Addendum #2

IFB # 21-005

GOLDMINE PARK

Questions and Clarifications

Sheet - 9, Erosion & Sediment Control Plan - intermediate Phase

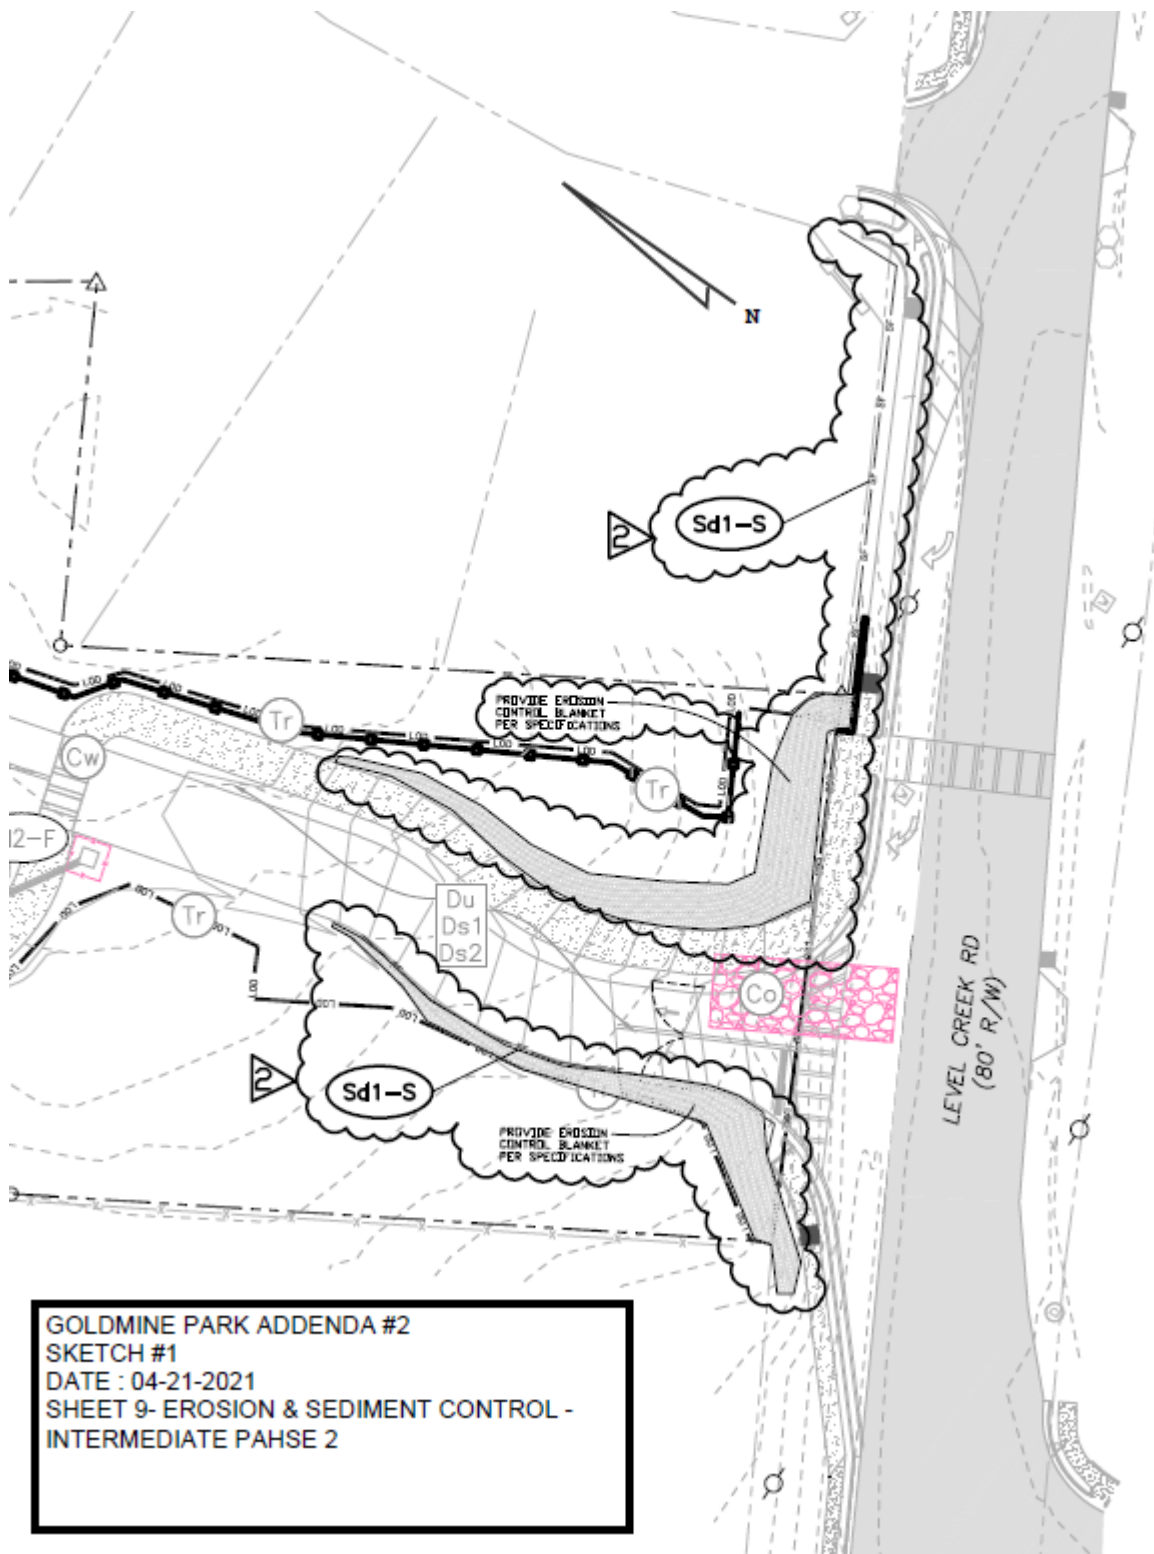
1.18 There are currently no BMP's shown in the right of way of Level Creek. Can you provide clarification if additional BMP's will be required?

HGB Response - Provide additional type-S silt fencing (+/- 300 lf) and Erosion Control Blanket (+/- 350 SY) as depicted on the attached sketch. Silt fence shall be per detail Sd1-S sheet 12, Erosion Control Blanket shall be "Curlex II" with biodegradable FibreNet on both sides, BioD-StrawCoco with 30% coconut fiber matrix and natural biodegradable netting on both sides, "Tensar, North American Green BioNet SC150BN" erosion control blanket with biodegradable thread and 30% coconut fiber matrix, or Other approved equal.
